City of Irvine
Parks Master Plan
FINAL | JULY 2015

ADA Assessment of Play Areas in Irvine Parks

TECHNICAL SUPPLEMENT

Northwood Park: Ages 2 to 5 Play Equipment Area

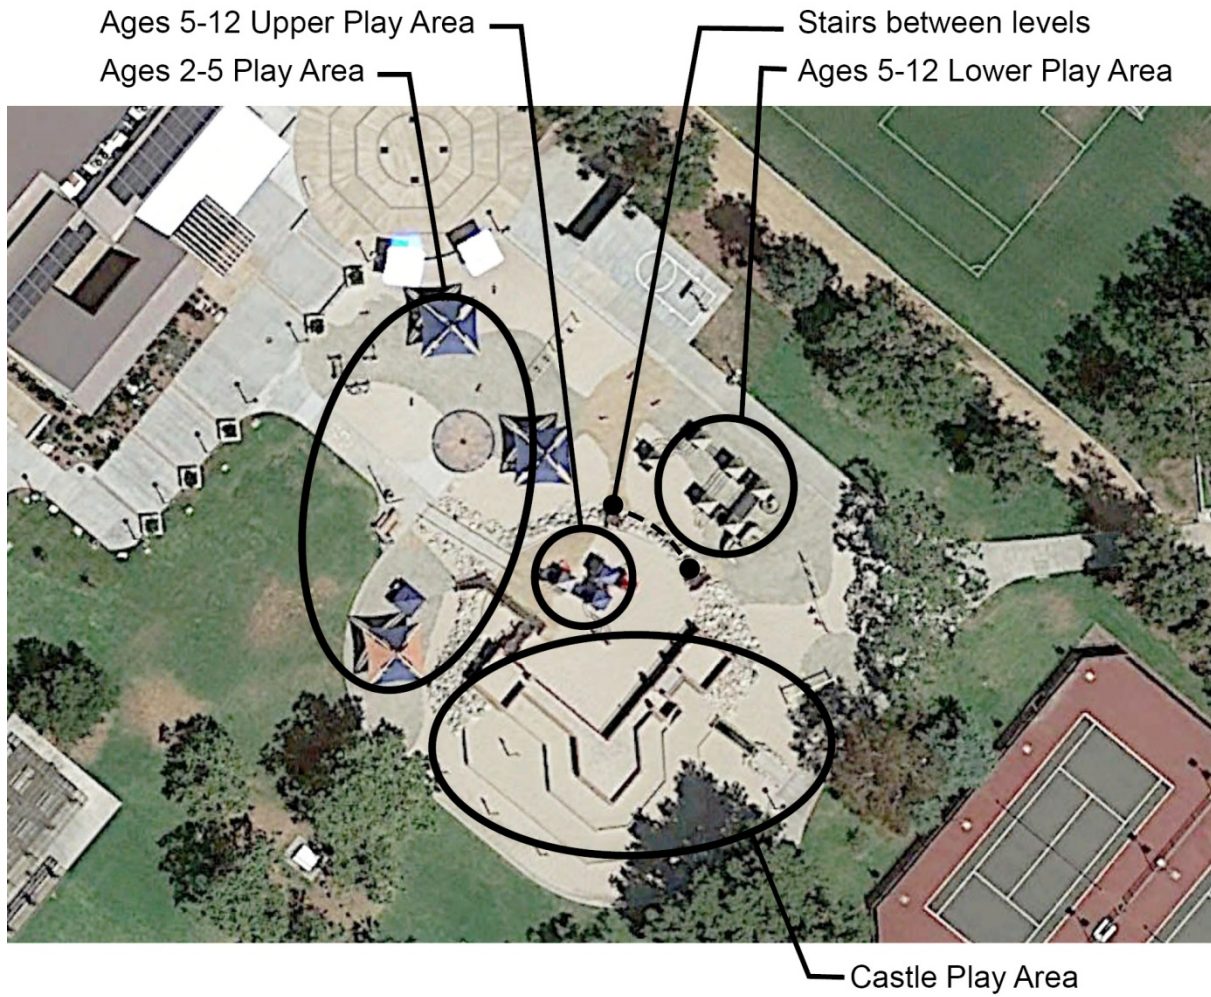
Action	Action Note	Planning Cost Estimate	Relevant Code
Improve or evaluate play area surface	Further evaluation of fall attenuation surface is recommended.	\$0	CBC 11B-1008.2.6.1 ADA 1008.2.6.1 ADA 1008.2.6.2
Install tread striping	Striping is not provided on stairs connecting play components.	\$200	CBC 11B-210.1 CBC 11B-504.4.1
Provide play components	Knee space is not provided at sand tables located off of poured in place surface due to sand (knee clearance is required to be 24 inches high minimum, 17 inches deep minimum, and 30 inches wide minimum, unless clear space for a parallel approach is provided).	\$800	CBC 11B-1008.4.3 ADA 1008.4.3
Provide an accessible path of travel	Vertical clearance at shade structure covering play area near picnic tables is 62-1/2 inches (80 inches minimum required).	\$125	CBC 11B-1008.2, ADA 1008.2
Total		\$1,125

Racquet Park: Ages 2 to 5 Play Equipment Area

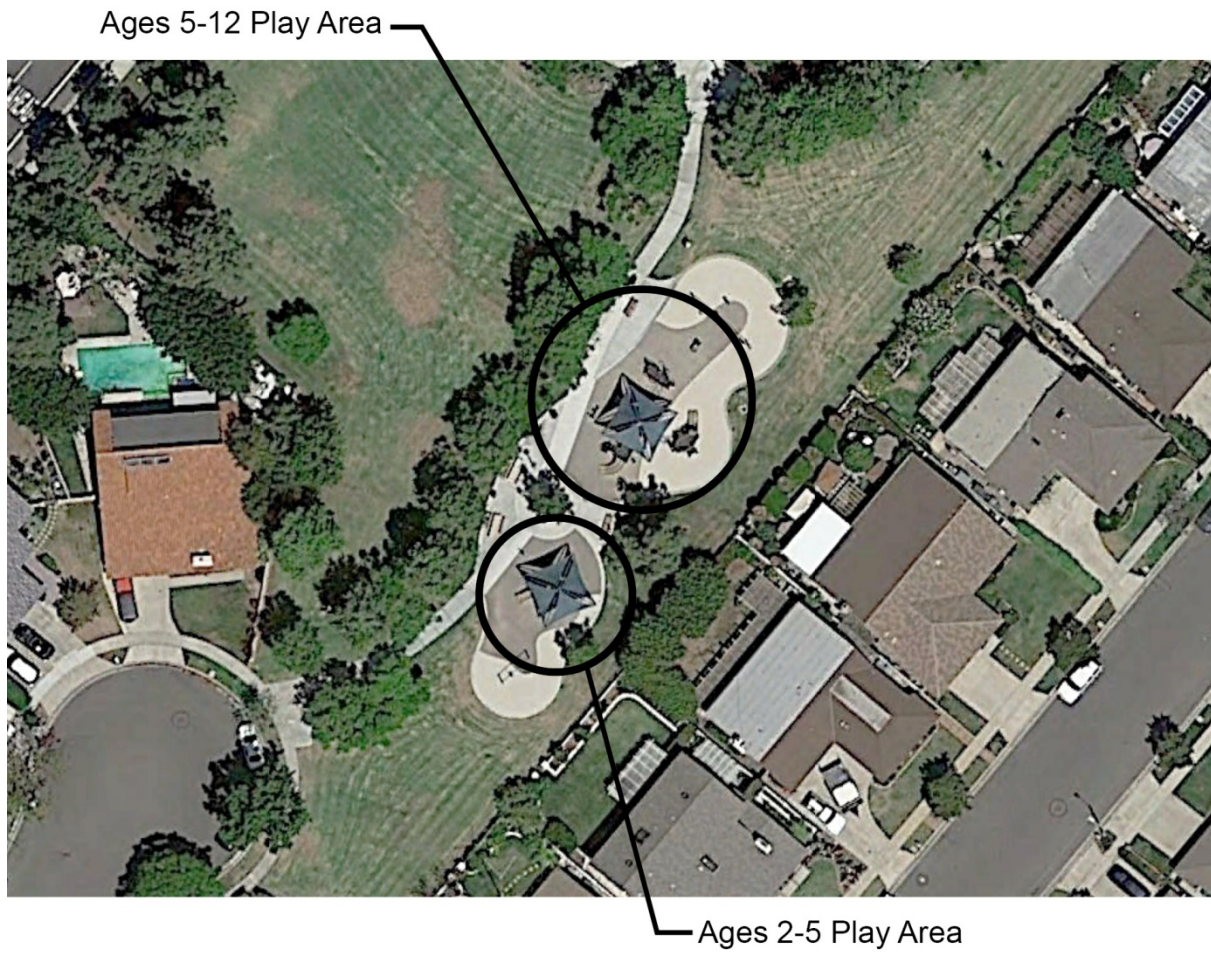
Action	Action Note	Planning Cost Estimate	Relevant Code
Improve or evaluate play area surface	Further evaluation of fall attenuation surface is recommended.	\$0	CBC 11B-1008.2.6.1 ADA 1008.2.6.1 ADA 1008.2.6.2
Install tread striping	Striping is not provided on stairs connecting play components.	\$200	CBC 11B-210.1 CBC 11B-504.4.1
Total		\$200

Ranch Park: Ages 5 to 12 Play Equipment Area

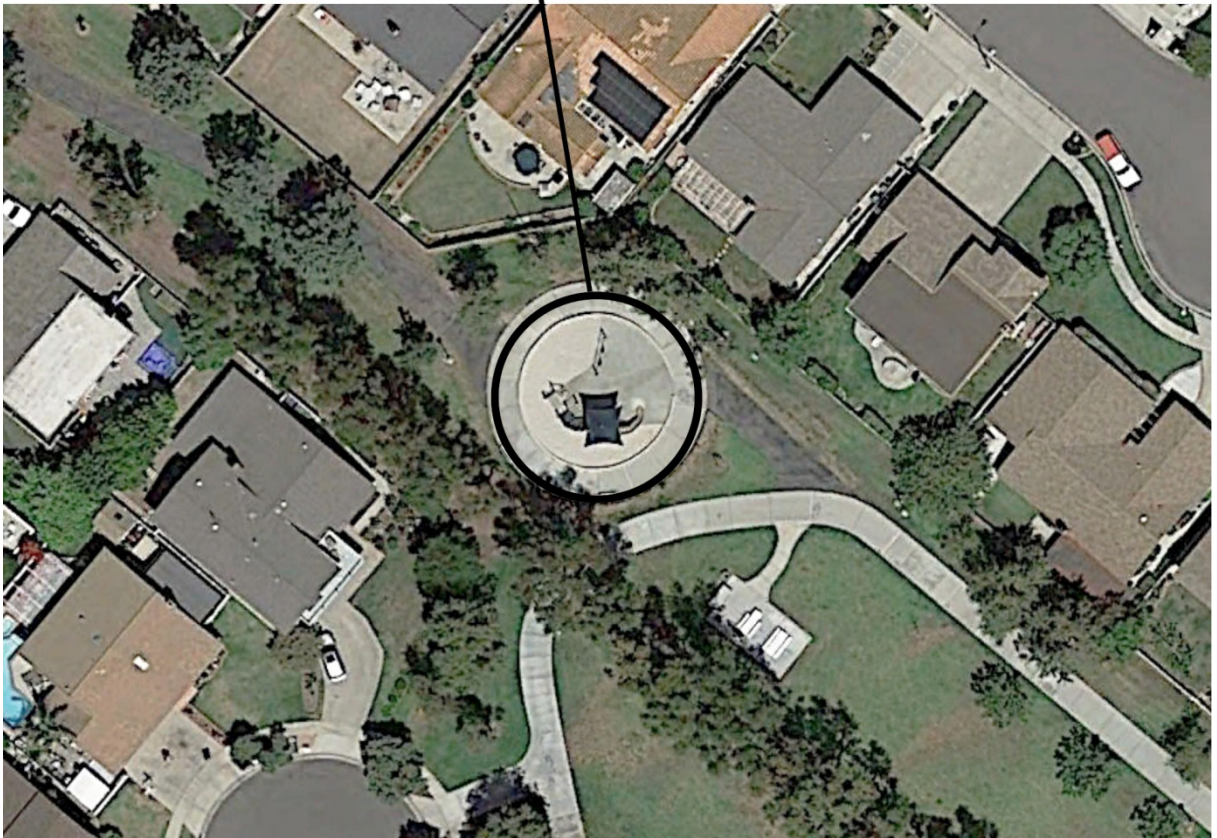
Action	Action Note	Planning Cost Estimate	Relevant Code
Improve or evaluate play area surface	Further evaluation of fall attenuation surface is recommended. Sand has migrated on to poured in place surface. Surface needs on-going maintenance.	\$0	CBC 11B-1008.2.6.1 ADA 1008.2.6.1 ADA 1008.2.6.2
Install tread striping	Striping is not provided on stairs connecting play components.	\$200	CBC 11B-210.1 CBC 11B-504.4.1
Provide play components	Knee space at play table is 21-3/4 inches high (24 inches minimum height is required).	\$5,000	CBC 11B-1008.4.3 ADA 1008.4.3
Total		\$5,200

Ages 5-12 Play Area

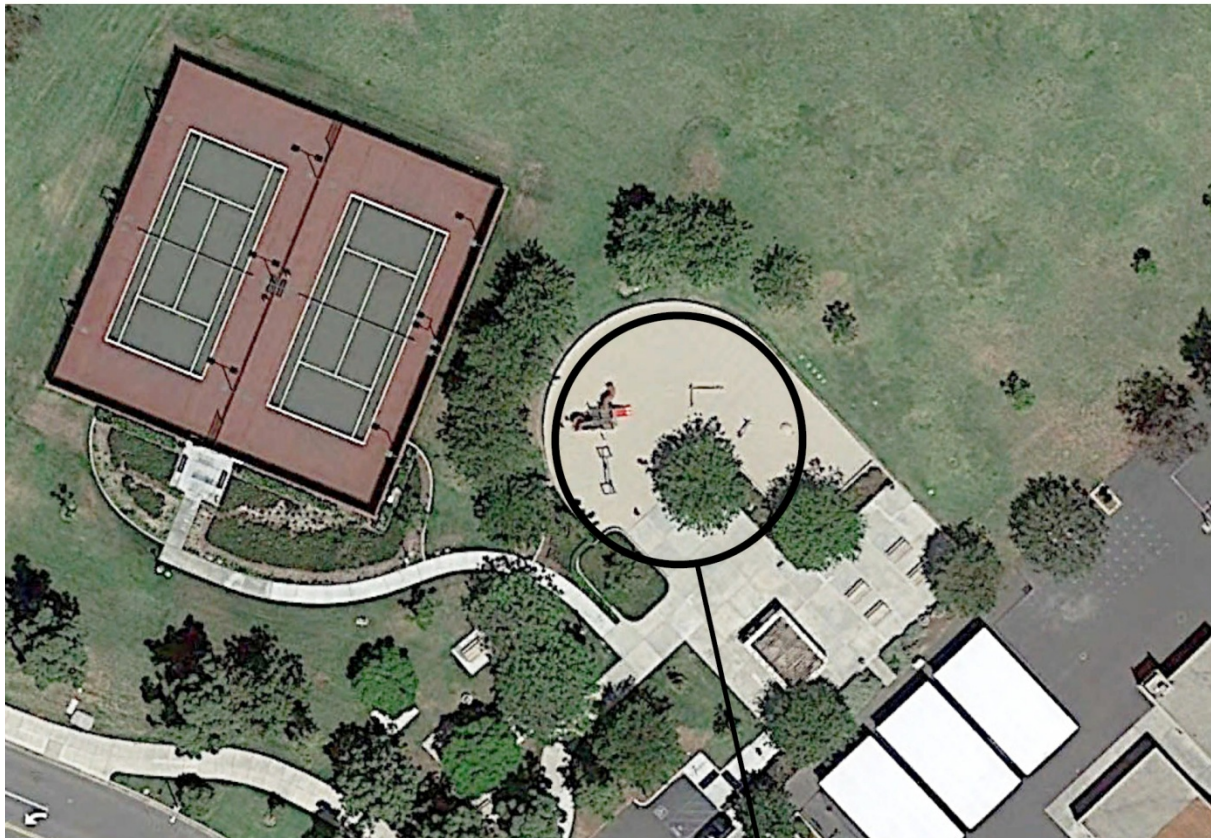
Action	Action Note	Planning Cost Estimate	Relevant Code
Improve or evaluate play area surface	Sand surface is not considered an accessible ground surface.	\$0	CBC 11B-1008.2.6.1 ADA 1008.2.6.1 ADA 1008.2.6.2
Provide an accessible path of travel	An accessible route to the play equipment area is not provided due to sand surface.	\$8,000	CBC 11B-206.2.17 CBC 11B-206.2.17.1 CBC 11B-1008.2 ADA 1008.2 ADA 206.2.17
Modify play component	The 30 by 48 inch clear floor space is not provided at any of the play components due to sand surface.	\$1,200	CBC 11B-1008.4.1 CBC 11B-1008.4.2 ADA 1008.4.1 ADA 1008.4.2
Install tread striping	Striping is not provided on stairs connecting play components.	\$200	CBC 11B-210.1 CBC 11B-504.4.1
Install or modify transfer system	A transfer system is not provided to elevated play components. Decks have changes in level ranging from 13 to 14 inches (eight inches maximum is permitted). A 30 by 48 ground space with a slope of 2.0 percent maximum is not provided due to sand surface.	\$5,000	CBC 11B-1008.3 CBC 11B-1008.3.1.3 CBC 11B-1008.3.2 CBC 11B-1008.3.2.1 CBC 11B-1008.3.2.2 ADA 1008.3 ADA 1008.3.1.3 ADA 1008.3.2 ADA 1008.3.2.1 ADA 1008.3.2.2

Stonegate Park: Ages 2 to 5 Play Equipment Area

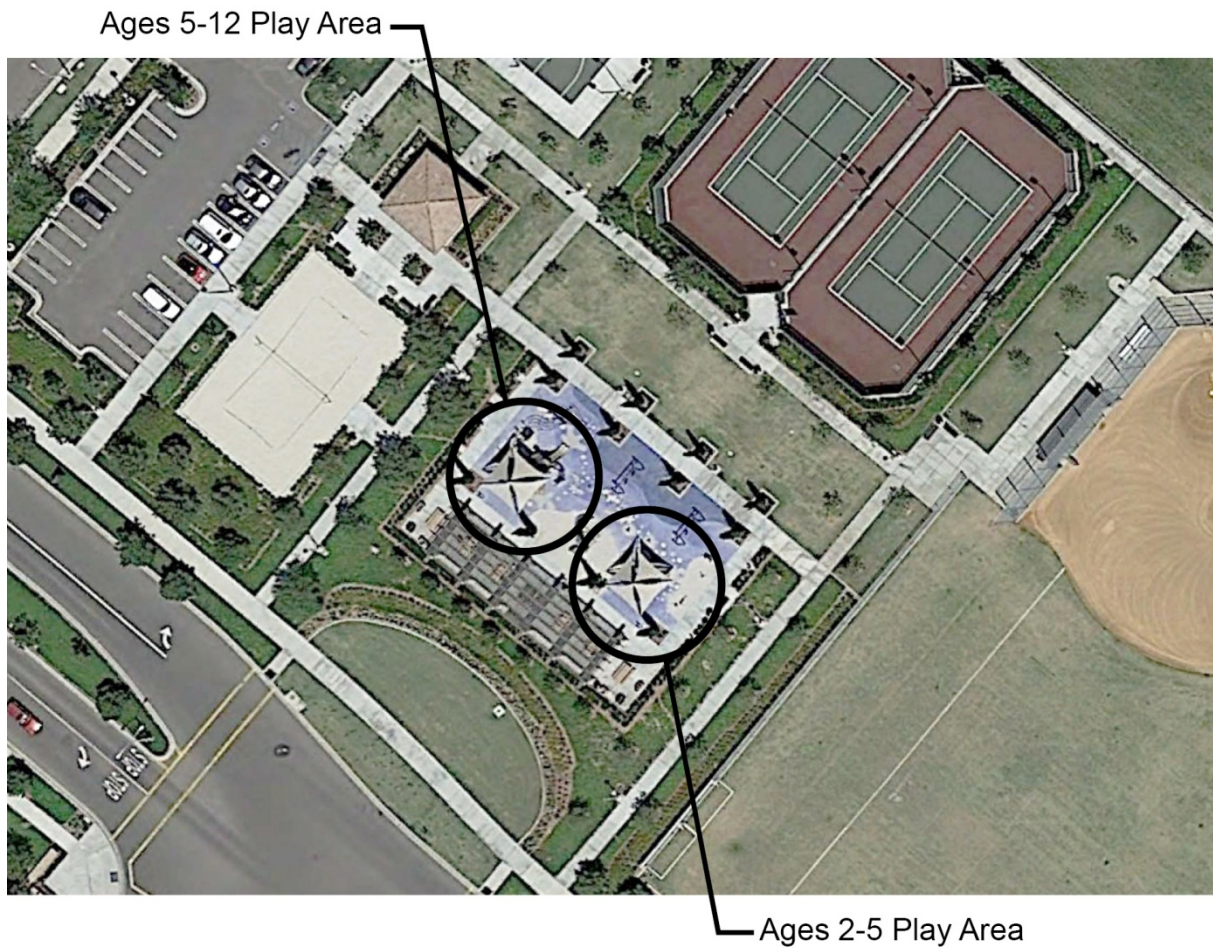
Action	Action Note	Planning Cost Estimate	Relevant Code
Improve or evaluate play area surface	Further evaluation of fall attenuation surface is recommended.	\$0	CBC 11B-1008.2.6.1 ADA 1008.2.6.1 ADA 1008.2.6.2
Install tread striping	Striping is not provided on stairs connecting play components.	\$200	CBC 11B-210.1 CBC 11B-504.4.1
Provide play components	Knee space at play table is 20-3/4 inches high (24 inches minimum height required). The table is not positioned to allow for a parallel approach. Table is 11 inches behind front of benches and not set up for parallel approach.	\$5,000	CBC 11B-1008.4.3 ADA 1008.4.3
Total		\$5,200

Sweet Shade Park: Ages 2 to 5 Play Equipment Area

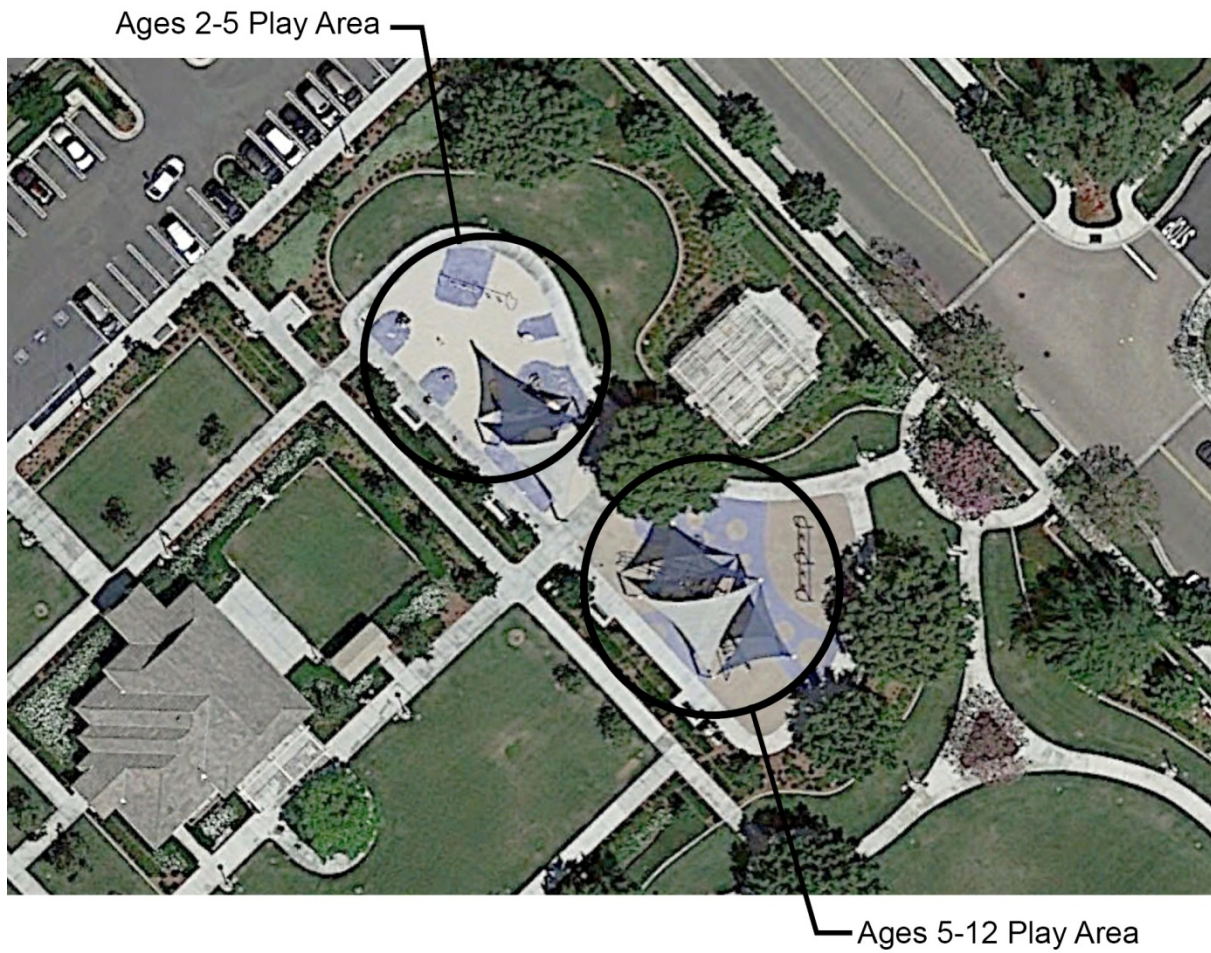
Action	Action Note	Planning Cost Estimate	Relevant Code
Improve or evaluate play area surface	Further evaluation of fall attenuation surface is recommended.	\$0	CBC 11B-1008.2.6.1 ADA 1008.2.6.1 ADA 1008.2.6.2
Modify play component	A 30 by 48 inch minimum clear space with a slope of 2.0 percent maximum is not provided at each ground level component. Slope is up to 3.3 percent at play table under composite structure and up to 3.2 percent at boat play.	\$800	CBC 11B-1008.4.2 ADA 1008.4.2
Install tread striping	Contrasting striping is not provided on stairs connecting play components. Existing striping is a texture but does not provide adequate visual contrast.	\$200	CBC 11B-210.1 CBC 11B-504.4.1
Install or modify transfer system	The 30 by 48 ground space adjacent to transfer platform has a slope of up to 3.0 percent (2.0 percent maximum allowed). Top transfer step is 8-1/4 inches high (eight inches maximum allowed). Vertical clearance between transfer platform surface and panel is 20 to 24 inches. This should be further examined as to whether it inhibits the functionality of the transfer. A transfer platform is not provided at second boat area closest to parking lot.	\$5,000	CBC 11B-1008.3.1.3 CBC 11B-1008.3.2.1 CBC 11B-1008.3.2.2 ADA 1008.3.1.3 ADA 1008.3.2.1 ADA 1008.3.2.2

Provide an accessible path of travel	Ground level route into boat play component nearest is between 15 to 36 inches wide (60 inches minimum wide required).	\$125	CBC 11B-1008.2.4.1 ADA 1008.2.4.1

Action	Action Note	Planning Cost Estimate	Relevant Code
Provide play components	Four of the six elevated play components are beyond a 29 to 31 inch wide path of travel that is 28 inches long (32 inches minimum width for 24 inches maximum allowed).	\$5,000	CBC 11B-240.2.2 ADA 240.2.2
Total		\$11,125

Turtle Rock Park: Panel Play Equipment Area

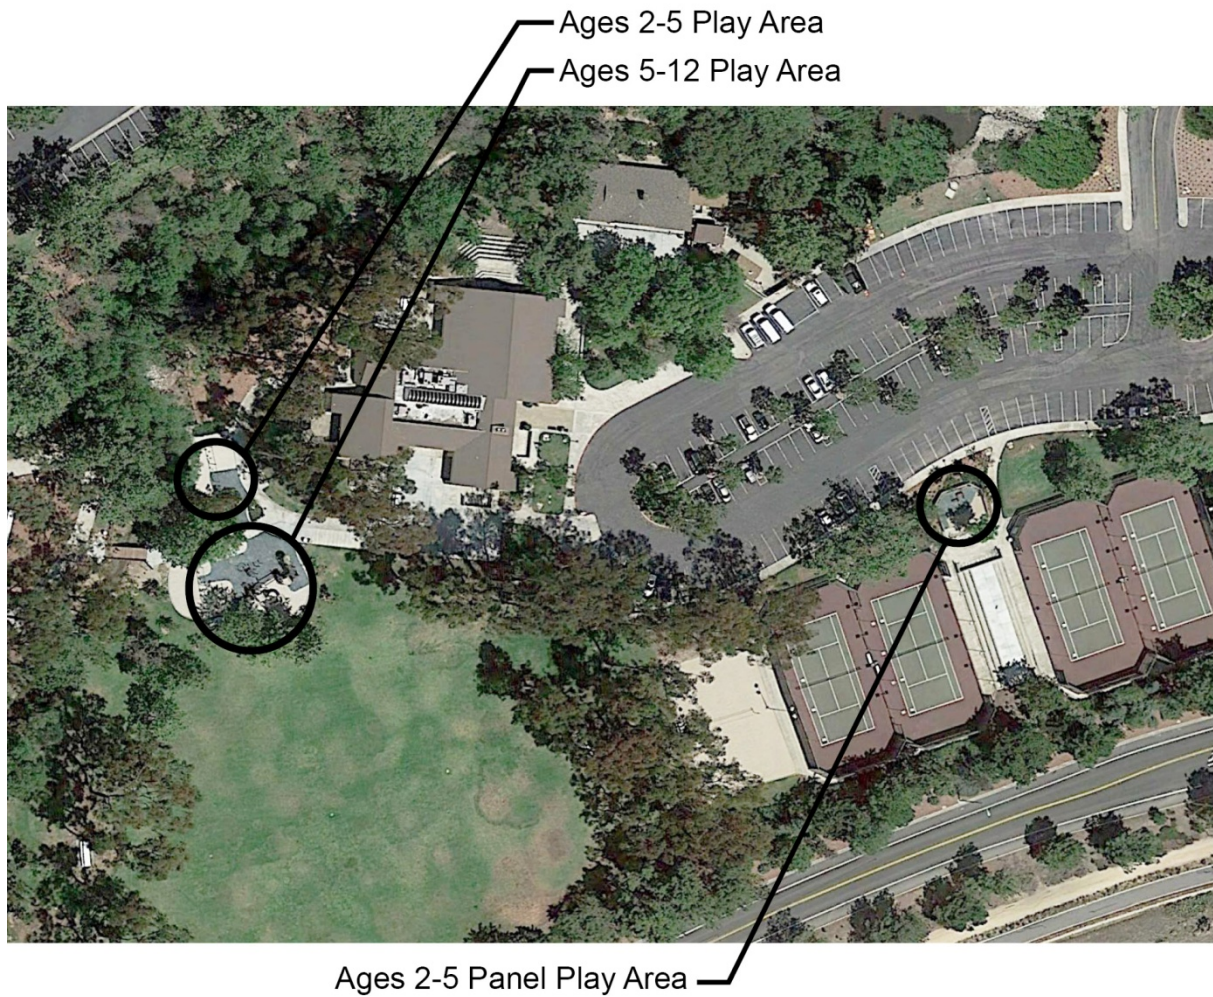
Action	Action Note	Planning Cost Estimate	Relevant Code
Improve or evaluate play area surface	Further evaluation of fall attenuation surface is recommended. Edges of poured in place surface are fraying.	\$0	CBC 11B-1008.2.6.1 ADA 1008.2.6.1 ADA 1008.2.6.2
Modify play component	The 30 by 48 inch minimum clear space at four-in-a-row panel is up to 3.5 percent (2.0 percent maximum is allowed).	\$400	CBC 11B-1008.4.2 ADA 1008.4.2
		\$400

Valley Oak Park: Ages 2 to 5 Play Equipment Area

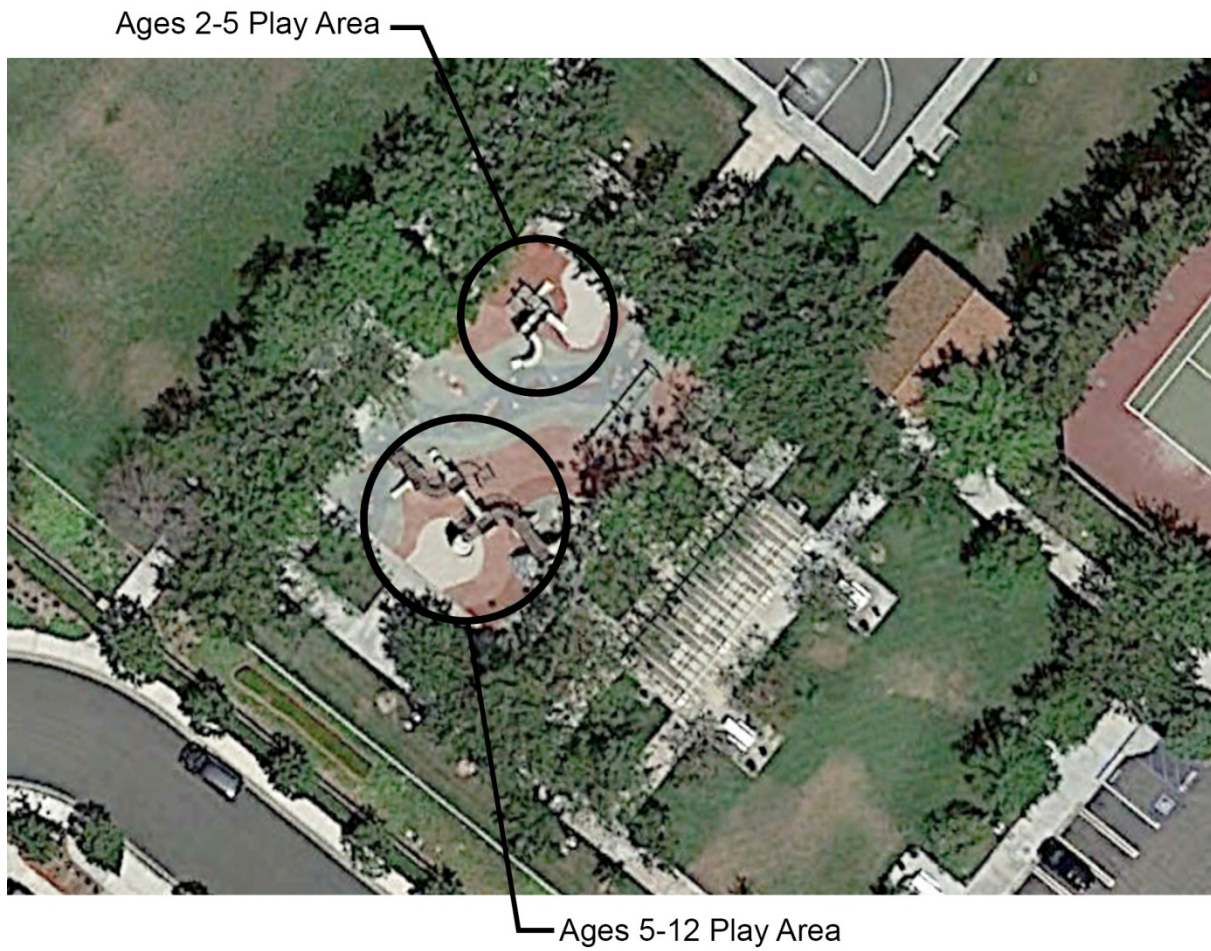
Action	Action Note	Planning Cost Estimate	Relevant Code
Improve or evaluate play area surface	Further evaluation of fall attenuation surface is recommended.	\$0	CBC 11B-1008.2.6.1 ADA 1008.2.6.1 ADA 1008.2.6.2
Install tread striping	Striping is not provided on stairs connecting play components.	\$200	CBC 11B-210.1 CBC 11B-504.4.1
Install or modify transfer system	Transfer platform is 20-1/4 inches wide between vertical supports (24 inches minimum wide required).	\$125	CBC 11B-1008.3.1.1 ADA 1008.3.1.1
Provide play components	One ground level play component is provided for six elevated (two ground level components are required including two different types).	\$5,000	CBC 11B-240.2.1.2 ADA 240.2.1.2
Total		\$5,325
